**Item No. 4**  
**Design Review Committee**  
**October 5, 2022**

**SUBJECT:** **Case 24276: Substantive Site Plan Approval for 1266 Barrington Street,  
Halifax**

1. Approve the qualitative elements of the substantive site plan approval application for a ten-storey addition to the Waverley Inn at 1266 Barrington Street, Halifax as shown in Attachment A;
2. Approve the three (3) variances to the Land Use By-law requirements regarding streetwall height, upper storey side yard setback, and ground floor height as contained in Attachment B;
3. Accept the findings of the qualitative Wind Impact Assessment, as contained in Attachment C; and
4. Recommend the Development Officer accept the restoration of the existing heritage building as the post-bonus height public benefit for the development as outlined in Attachment D.

Figure 1 - Streetwall Height Variance

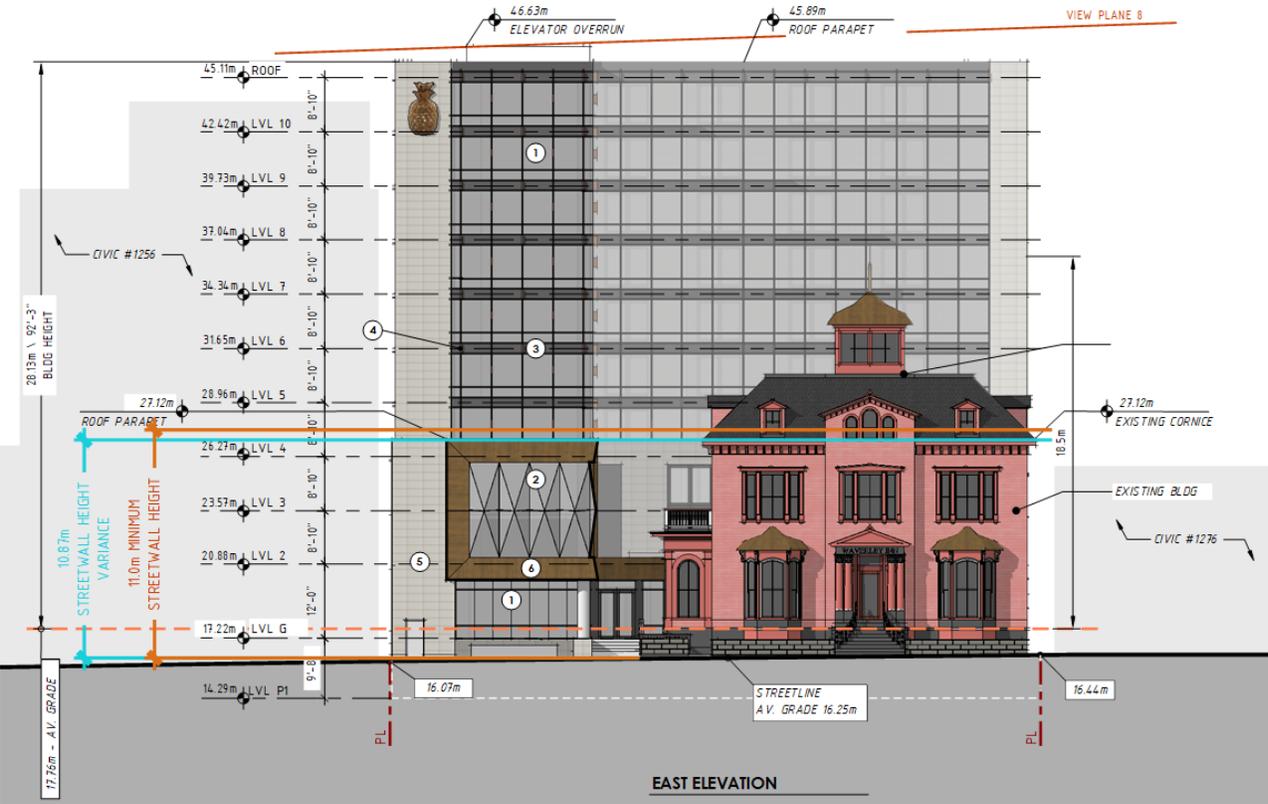
The proposed variance to the minimum streetwall height is requested to keep the streetwall height of the proposed addition consistent with the cornice line of the existing building, which is a contributing heritage resource. The variance helps the design adhere to the Heritage Design guidelines, specifically section 4.4.2(a) which provides guidance for development proposed for a site where a heritage resource exists. This section stipulates the development should maintain the same or similar cornice height to create a consistent streetwall height. Section 3.2.1(d) of the Design Manual says that in areas of contiguous heritage resources, streetwall height should be consistent with heritage buildings. The lower streetwall design helps bring consistency and transition to the Waverley Inn and the lower cornice lines of the other Old South Suburb Heritage Buildings immediately to the north on Barrington Street. The proposed streetwall height is in keeping with the intent of the Design Manual in addition to being minor relative to the standard of the Land Use By-law. Staff recommends approval of the variance for the minimum streetwall height.

We are requesting a variance to the streetwall height to reduce the minimum streetwall height to 10.87 metres as shown in Figure 1. The intention behind this variance request is to keep the streetwall height consistent with the cornice line of the existing heritage building. This variance is consistent with the design guidance of section 3.2.1 (d), which says that, "in areas of contiguous heritage resources, the streetwall height should be consistent with heritage buildings." Additionally, this variance aligns with guideline 4.4.2 which discusses maintaining the same or similar cornice height of a new building with adjacent heritage resources.

Figure 2 - Upper Storey Side Setback Variance

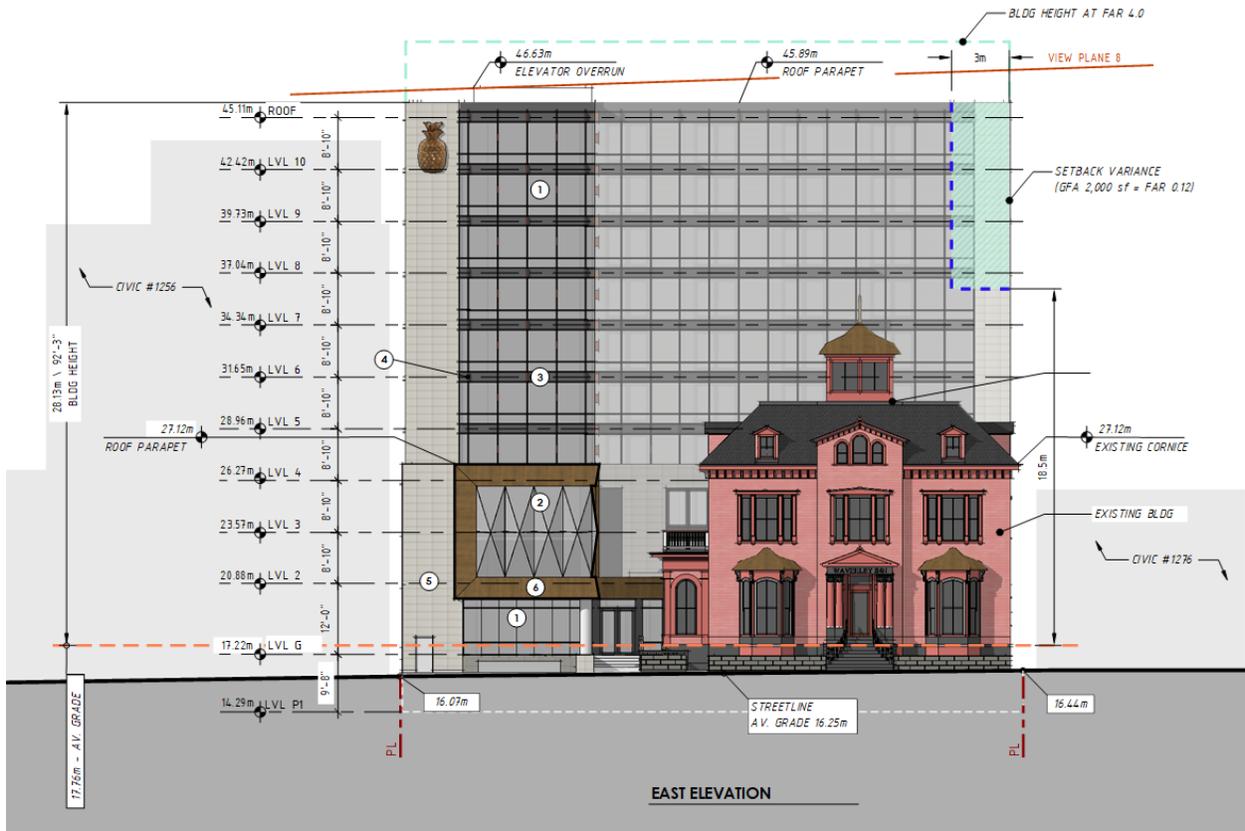
View Plane 8 extends across the subject site and limits the maximum height of the addition. As a result, the maximum floor area ratio that can be achieved is also limited. A floor area ratio of 4.00 is permitted on the site, but the maximum floor area ratio that can be achieved is 3.68. This translates to a 5,316 square foot smaller addition. The applicant is requesting to vary the upper storey side yard setback to recover 2,000 square feet of floor space lost to the height restriction. Staff advise the proposed setback does not detract from the heritage resource and keeps the proportions of the addition symmetrical, therefore staff recommends approval of the variance for the upper storey side yard setback.

We are requesting a variance to the Upper Storey Side Yard Stepback as indicated in Figure 2. As we understand it, the requirements of section 2.4(b) may be relaxed where the relaxation of the requirement is consistent with the Design Manual.

In this instance, a floor area ratio of 4.0 is permitted on the site. However, only a floor area ratio of 3.68 is achievable under the as-of-right land use bylaw requirements due to the presence of View Plane 8, which limits the maximum height of the building. This reduces to overall achievable gross floor area by 5,316 sqft. To recover some of that gross floor area and to resolve building code compliance issues on the site, we are requesting a variance to the upper storey streetwall setback to permit an additional 2,000 sqft (as indicated on Sheet A03).

The proposed stepback relaxation does not detract from the visual prominence of the existing heritage resource and therefore keeping consistent with Design Manual Guidance.

Figure 3 - Minimum Ground Floor Height Variance

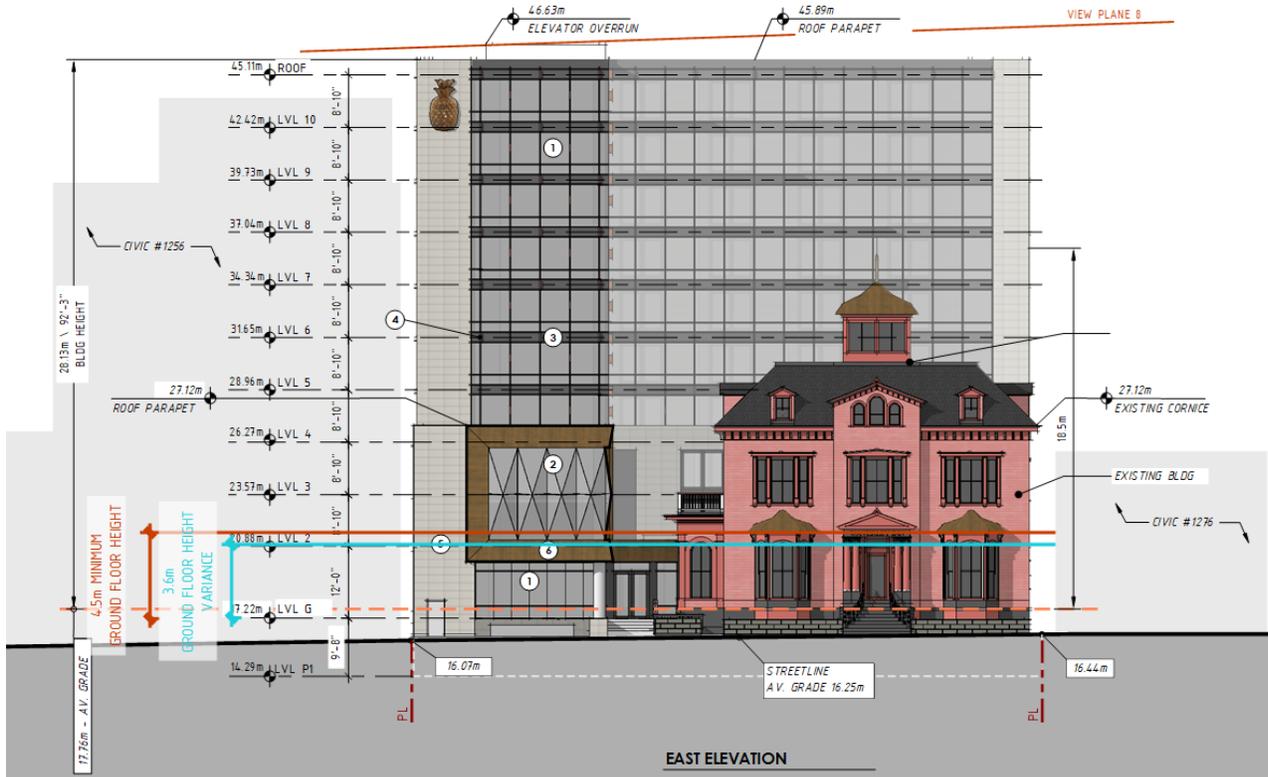
The existing building ground floor height is 4.6m and the proposed addition ground floor height is 3.6m as shown in Figure 3. It is not feasible to lower the ground floor elevation as this would impede on the clearance for the underground parking entrance. Additionally, lowering the ground floor elevation of the proposed addition would require internal ramping between the addition and existing building to meet accessibility requirements of the buildings code. However, there is not enough space internally to meet these requirements, rendering the connection between the proposed addition and existing building inaccessible.

It is not feasible to raise the parapet and top of the ground floor to achieve the requirements of section 8(13) because this would impact the cornice line detailing of

the existing Waverley Inn's breakfast room where the new addition connects with the existing building. The intent of this project is to restore the heritage detailing of the Waverley Inn and raising the ground floor height would conflict with that intent and the intent of guideline 4.3.3(f).
